**Blain's Farm and Fleet of Waukesha – Pet Wash  
Planning Commission Review Responses  
Project Number: SPAR24-00034**

**Project Location:** Blain's Farm and Fleet of Waukesha  
2310 Kossow Rd.  
Waukesha, WI

**Re:** Blain's Farm and Fleet responses to City of Waukesha questions regarding project SPAR24-00034

PROJECT NAME: FARM & FLEET OF WALKESHA 2310 KOSSOW ROAD WALKESHA, WISCONSIN 53186-2905	DRAWING NO. <b>C051</b>
	PROJECT TITLE: CONCRETE CURB REPLACEMENT PLAN

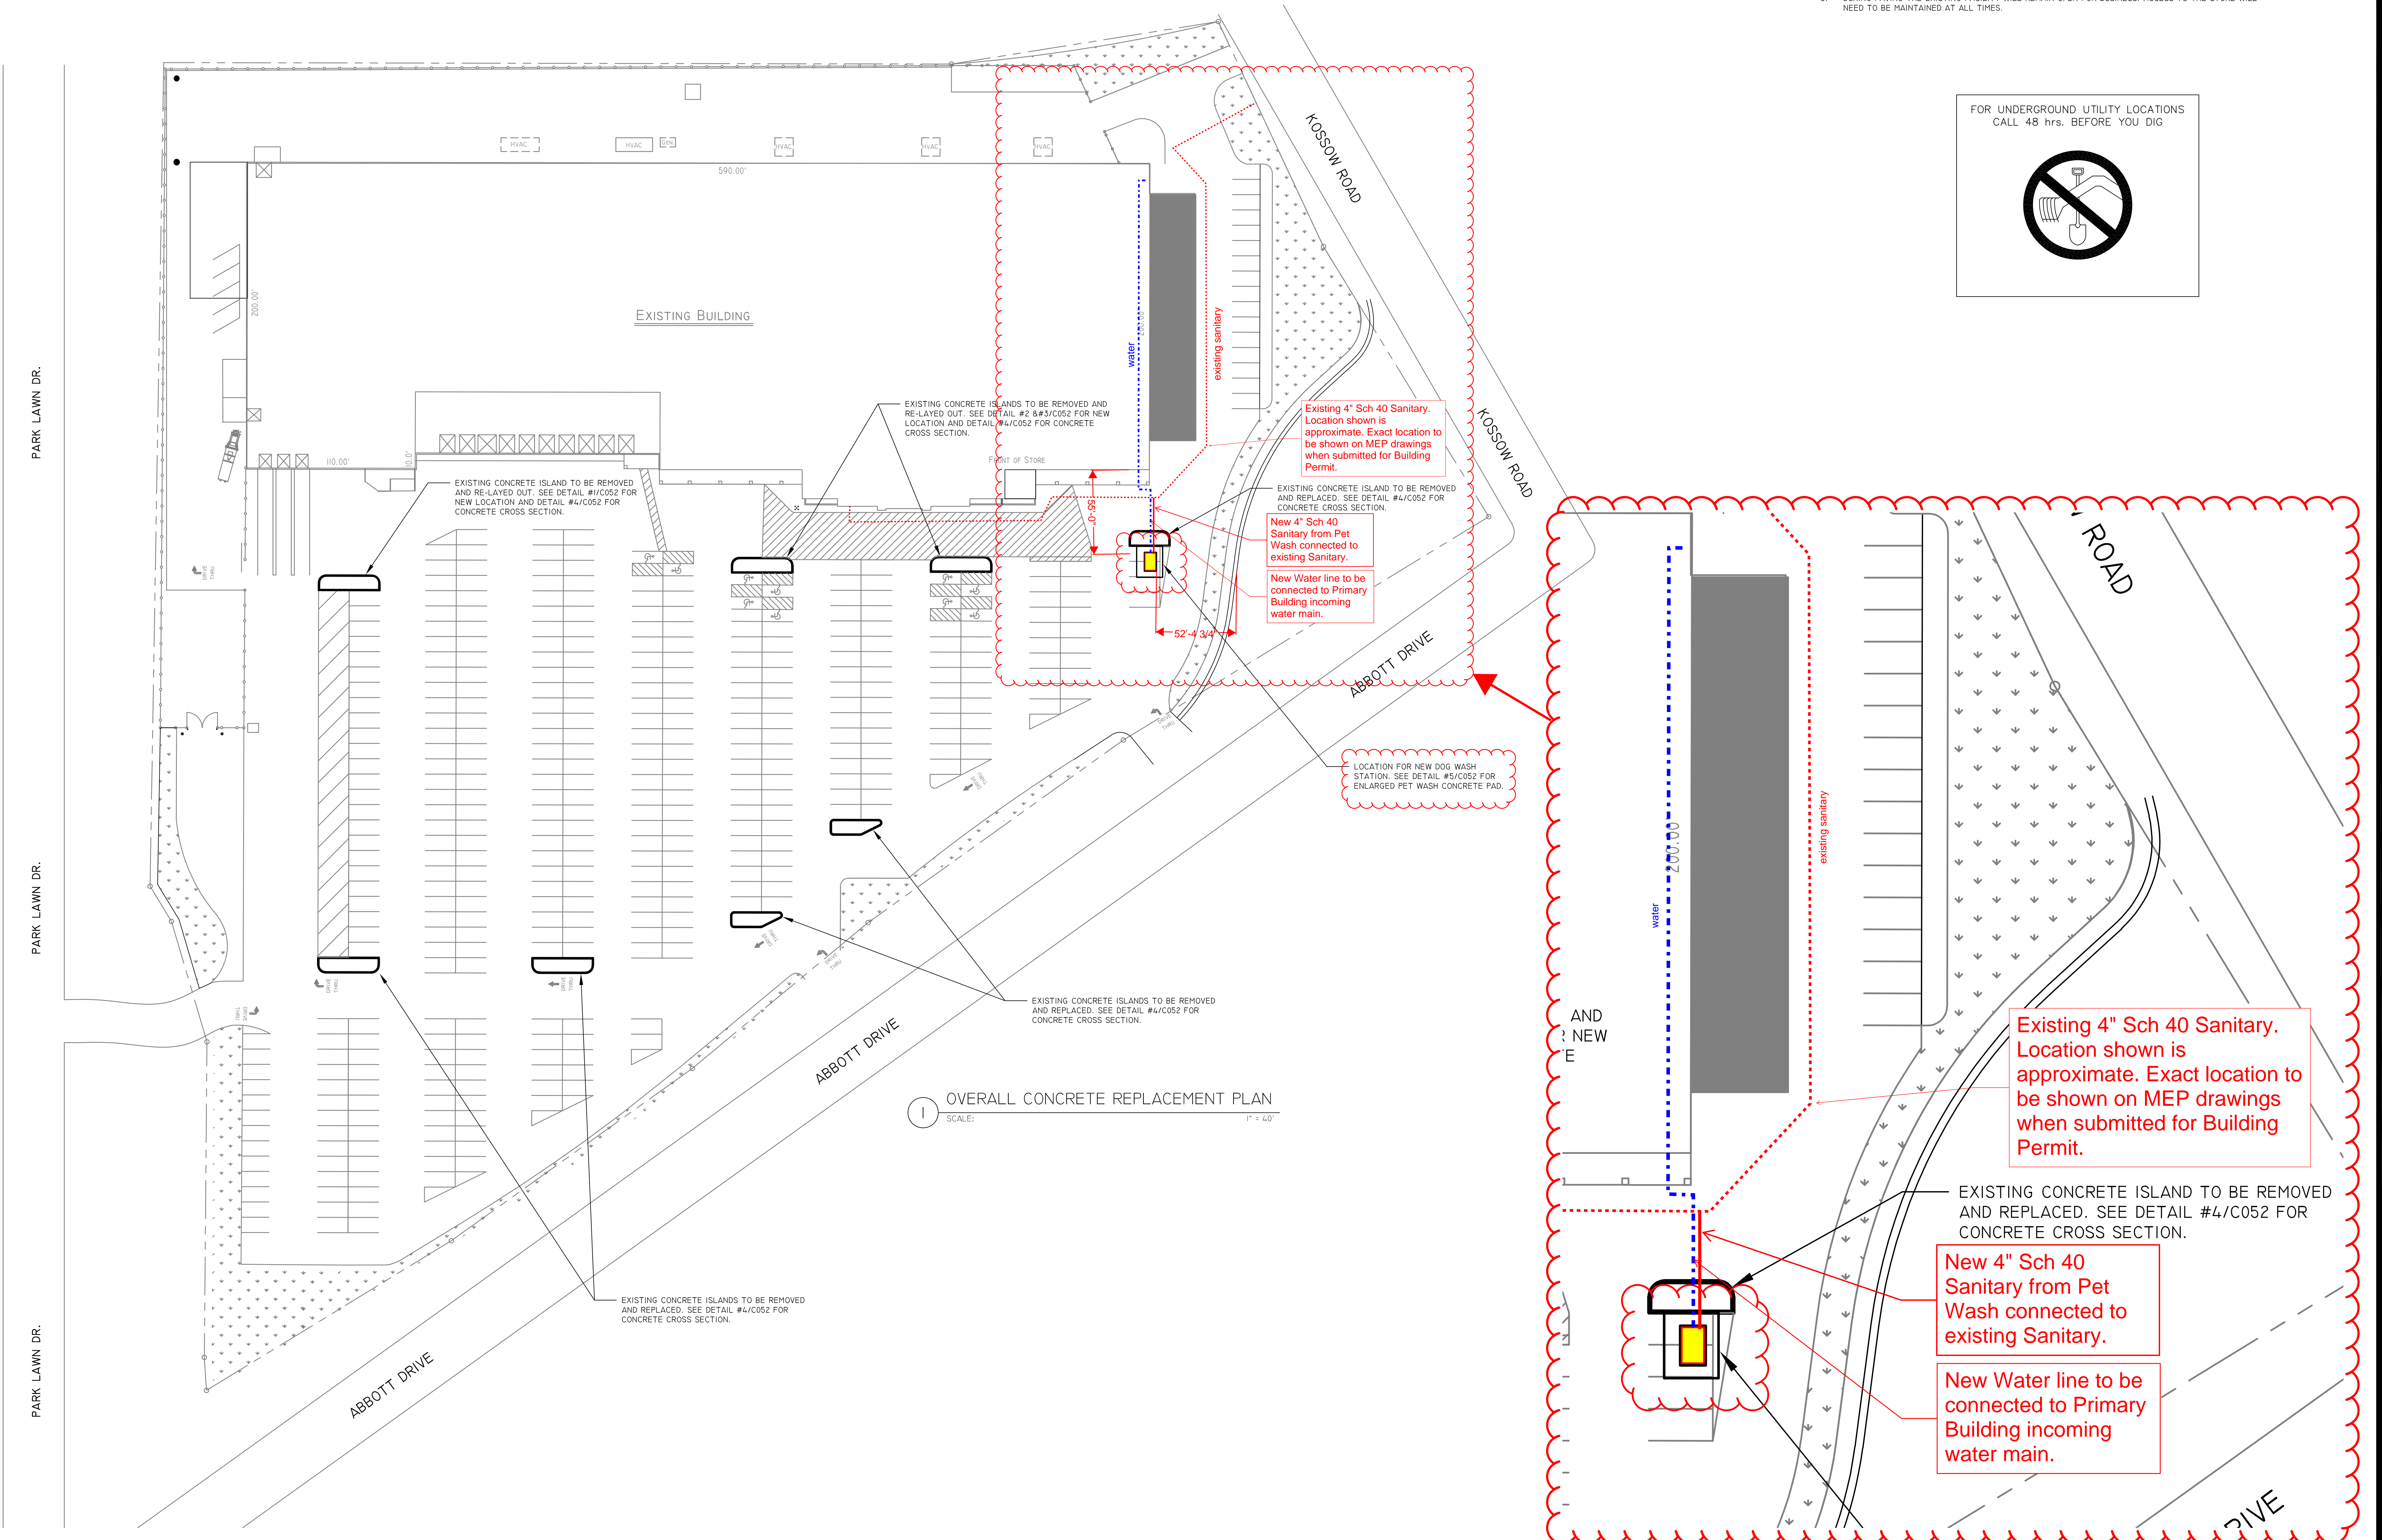
Storm Sewer	Jonathan Schapekahm	<p>Notes:</p> <p>How does water used at the wash station drain and to where does it drain?  <i>Blain's Response: Water used in the facility will be drained to an existing Sanitary Sewer line located along South Face of building. (See attached drawing.)</i></p>
	Street Desing	Craig Ausen	No comments
	Street Lighting	Jeff Hernke	<p>Notes:</p> <p>No comments regarding city owned street lights or fiber.</p>
	Traffic	Derrin Wolford	<p>Notes:</p> <p>No comments from the traffic section.</p>

5 PROPOSED DOG WASH AREA CONCRETE PAD  
SCALE: 1" = 10'

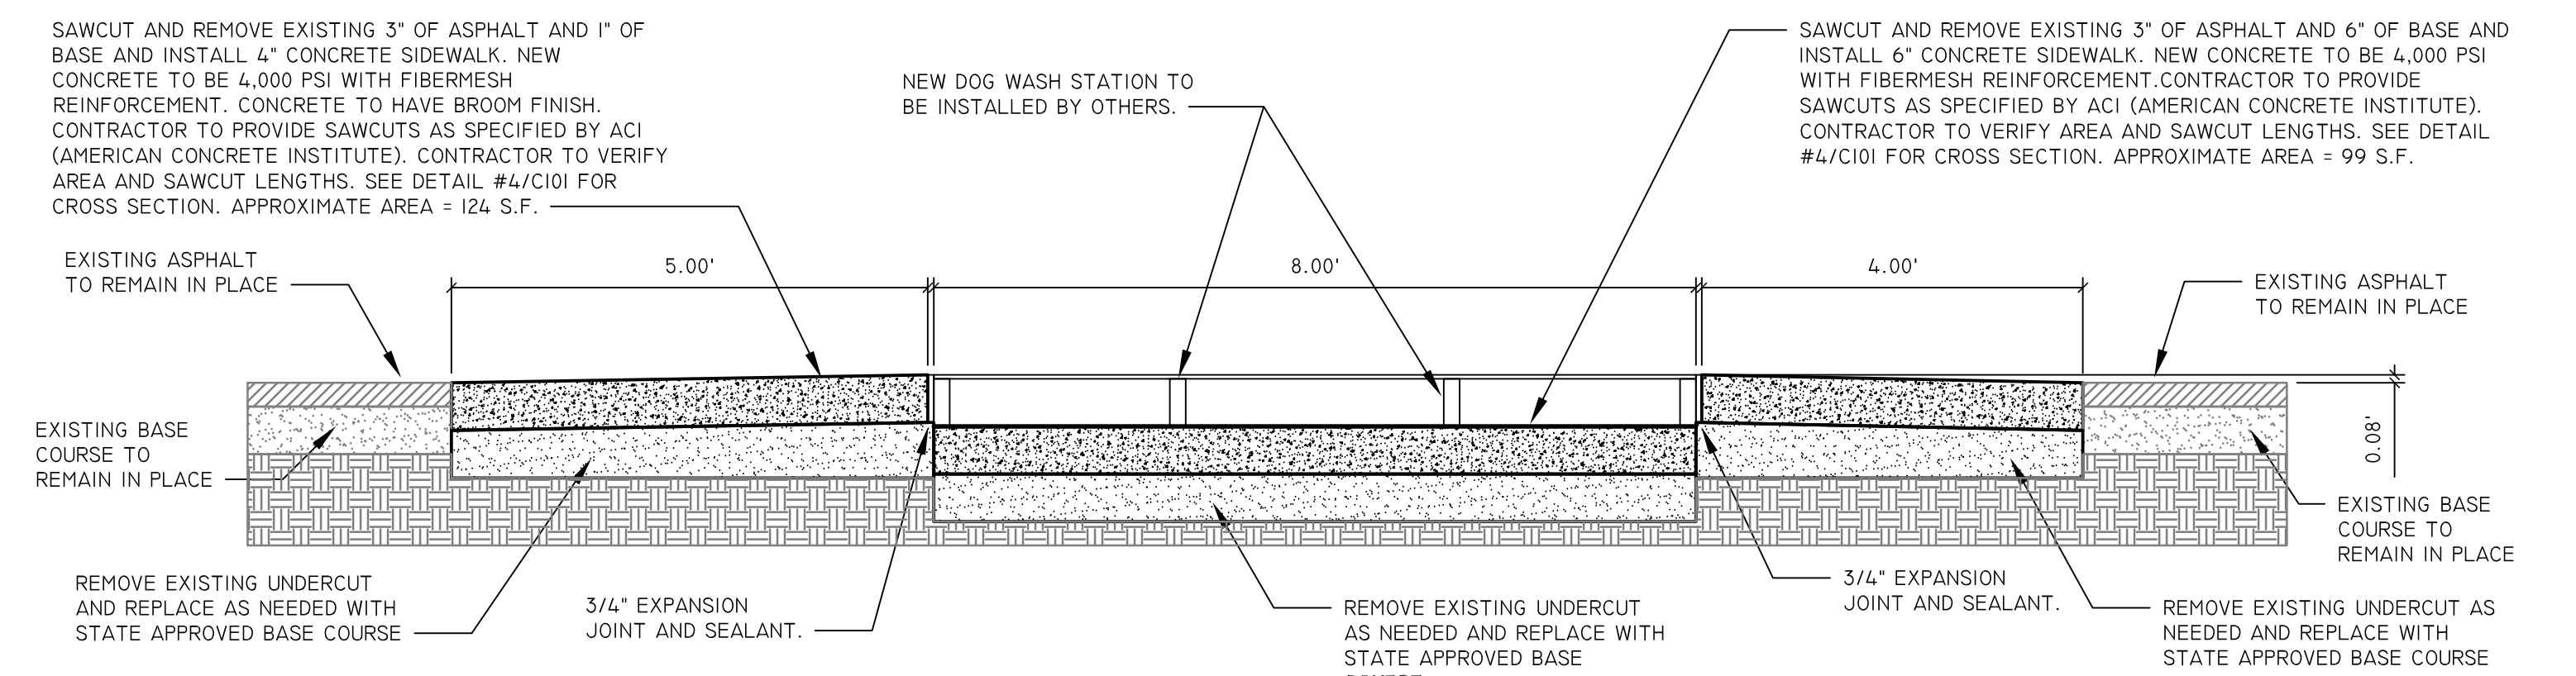
General Engineering	Brandon Schwenn	Notes: 1. Additional required submittals, fees, financial guaranties needed prior to issuance of building permit include: a. Financial guaranties b. Impact Fees c. Applicable sewer connection charges per Chapter 29.11(c) will be owed to the City for this project. 2. The construction drawings, and financial guarantees should be reviewed and approved prior to the construction being started and building permit issued. If the location of any work needs to be changed as a result of the approved construction drawings, the drawings should be updated to reflect the needed changes. 3. Submit all required checklists for Development Submittals. See City's Development Handbook. 4. Will there be water/sewer connections to this building since it is a pet wash? If no water connection, how will washing occur? If water is being utilized, is runoff entering storm sewer? <i>Blain's Response: Yes there will be water and sewer connections to the Pet Wash building. Please see attached Preliminary sketch. No run-off will enter the storm sewer.</i>

1. ALL WORK INCLUDED ON CONTRACT SHALL COMPLY WITH ALL LOCAL, STATE AND NATIONAL CODES.
2. CONCRETE CONTRACTOR SHALL CALL FOR UTILITY LOCATE.
3. DURING PAVING THE EXISTING FACILITY WILL REMAIN OPEN FOR BUSINESS. ACCESS TO THE STORE WILL NEED TO BE MAINTAINED AT ALL TIMES.
4. CONCRETE FOR DOG WASH AREA TO BE POURED IN (2) STAGES. (1) TO BE PAD UNDER DOG WASH AND (2) TO BE POURED AFTER DOG WASH STATION HAS BEEN PLACED.

Drawing No. **P.1**

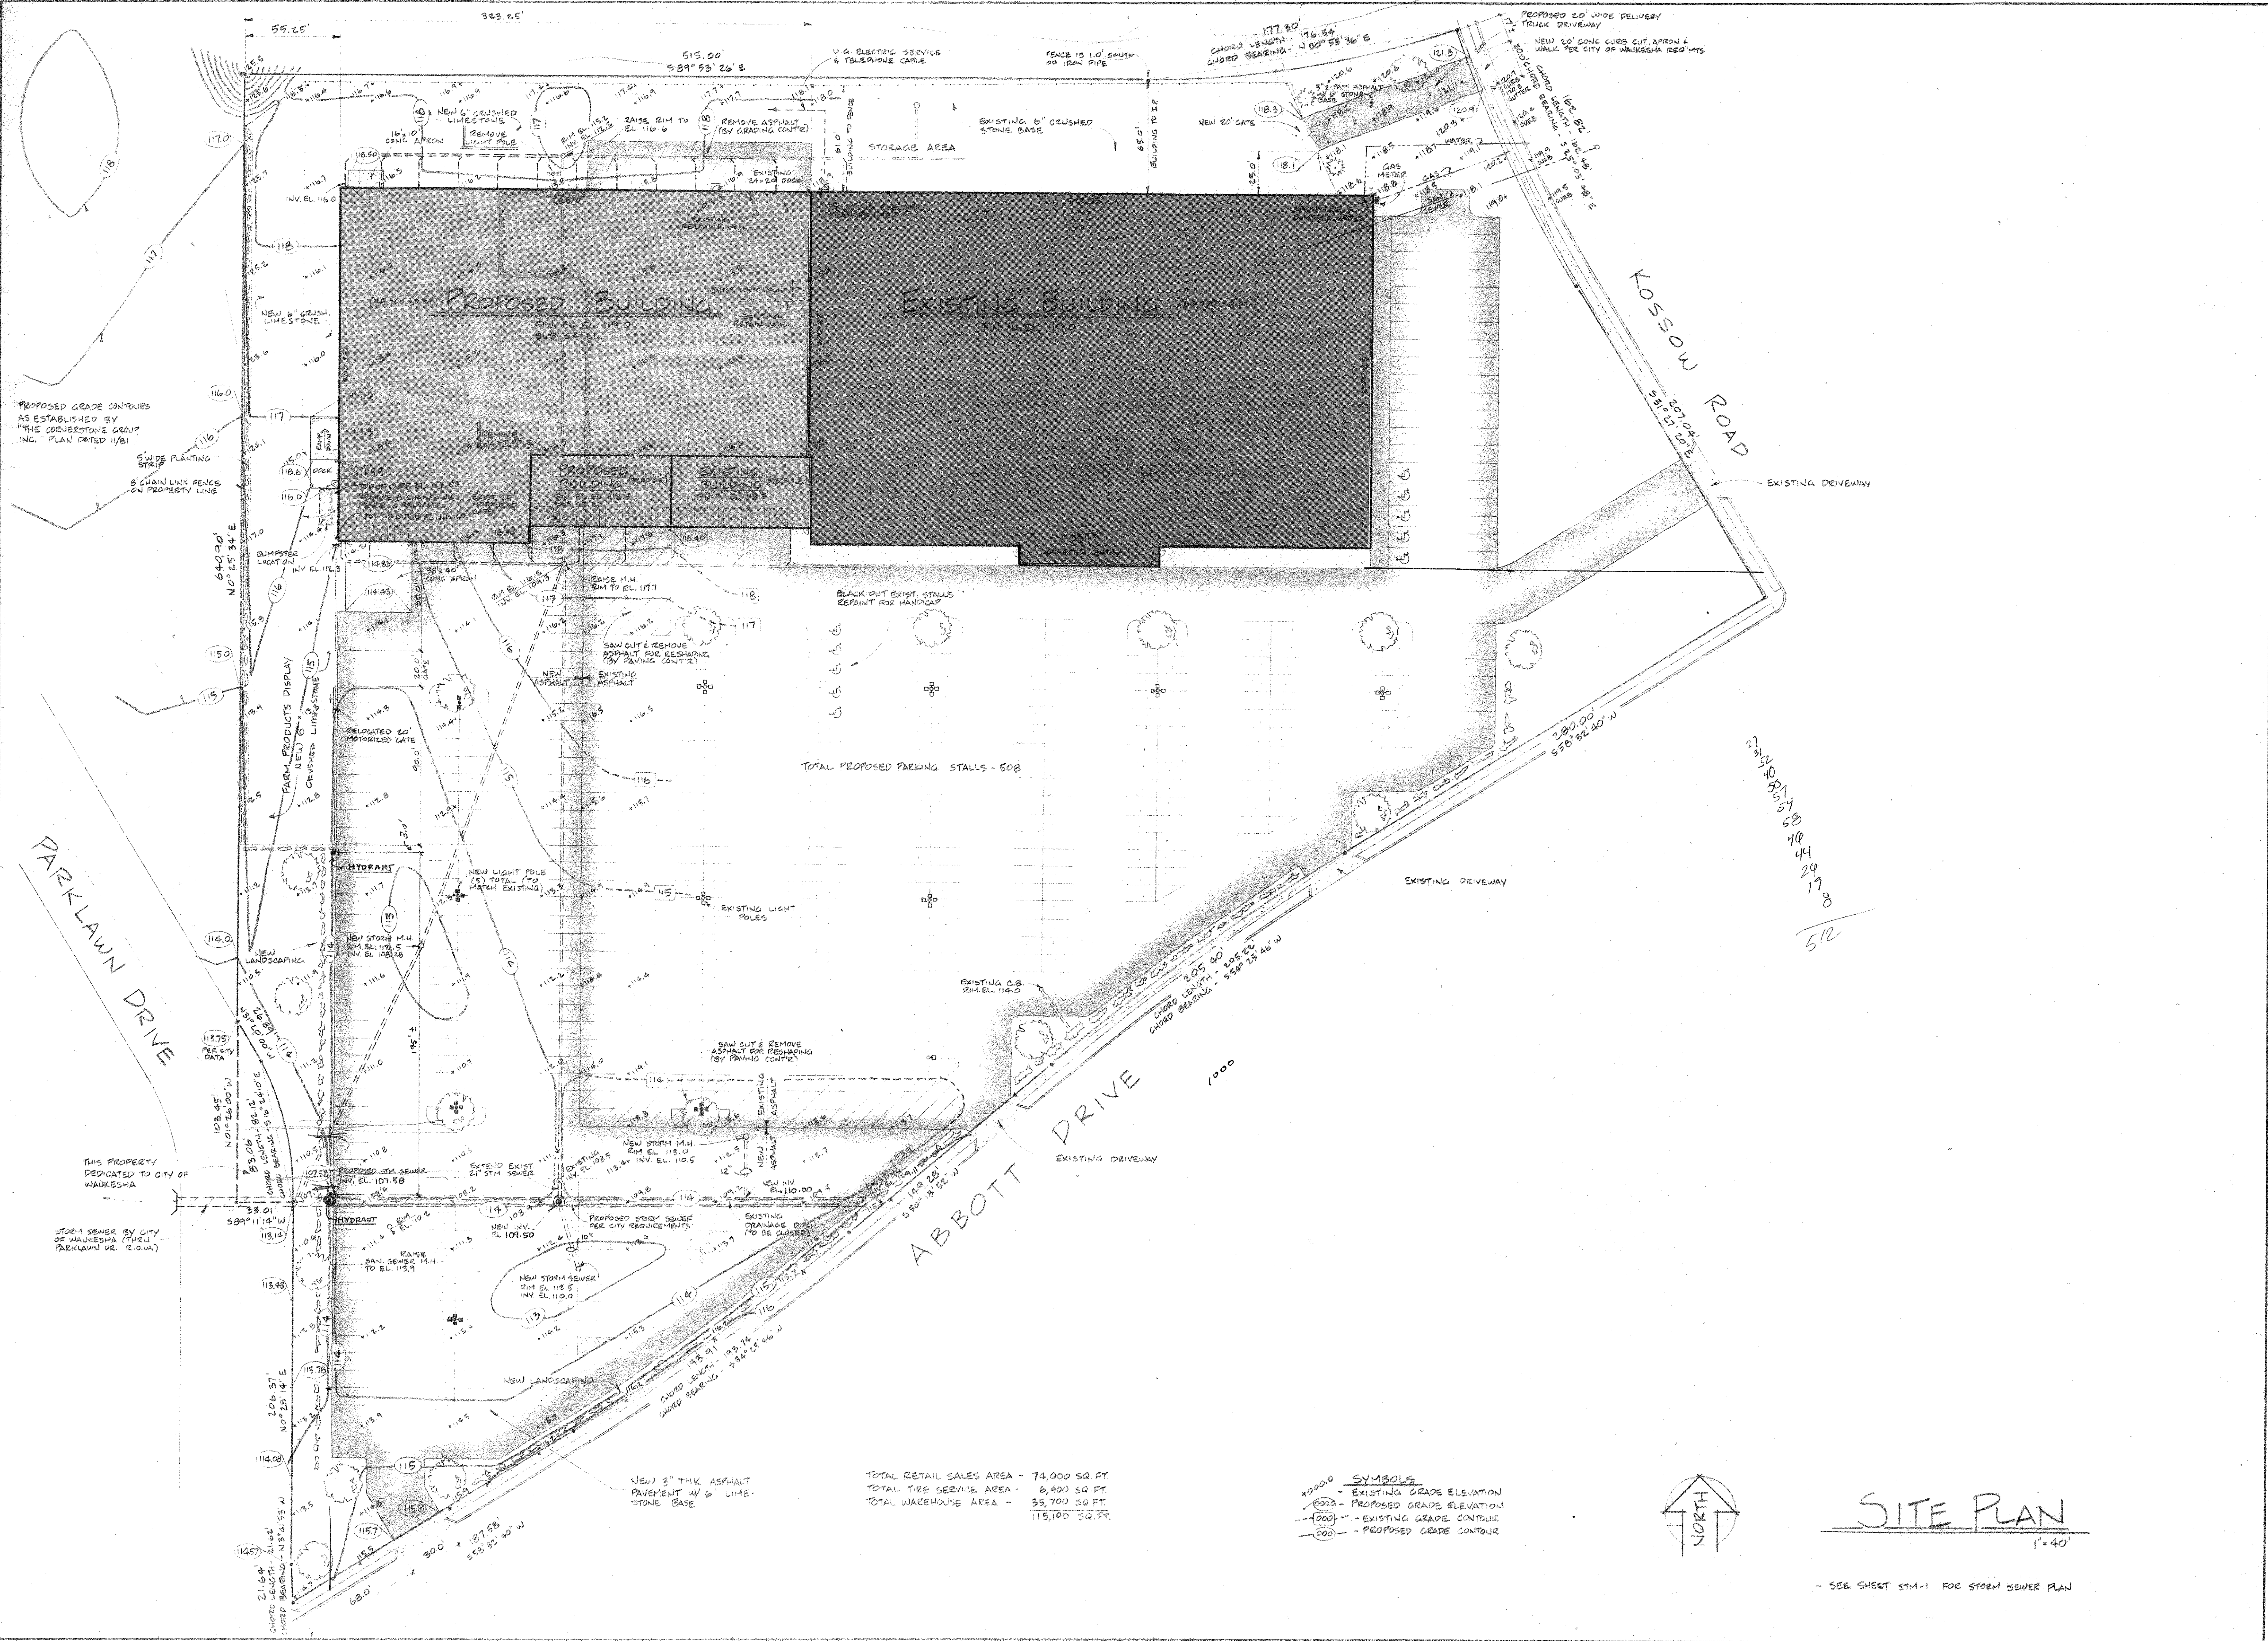
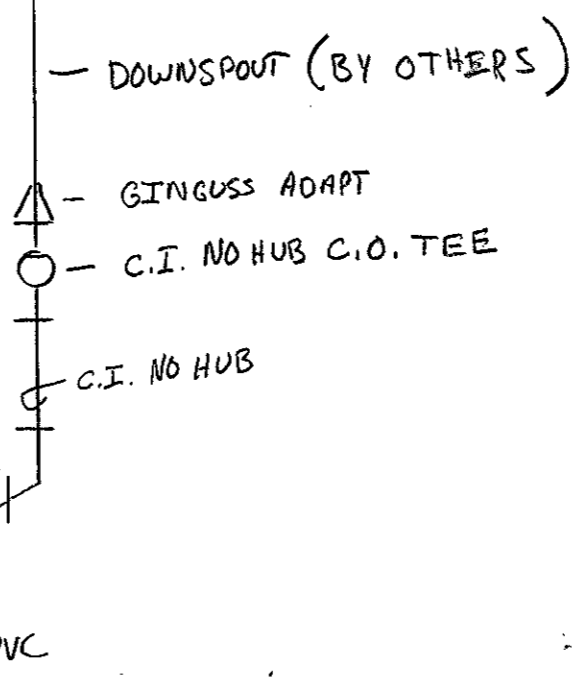
CORRECTION NEEDED  
 SEE CORRESPONDENCE  
 082.3.3.5700.1

CORRECTION NEEDED  
 SEE CORRESPONDENCE  
 082.3.3.5700.2

Plumbing contractor to connect New sanitary sewerline to existing sanitary sewer main, as required. Verify sanitary line inverts  
 IE = 91.50  
 FIELD VERIFY EXISTING SAN. LATERAL INV. PRIOR TO INSTALLING NEW 4" SAN. SEWER

New sanitary sewer line, connect to existing sanitary sewer main at south west corner of building.  
 130'  
 4" SAN.  
 @ 1/8" PPF
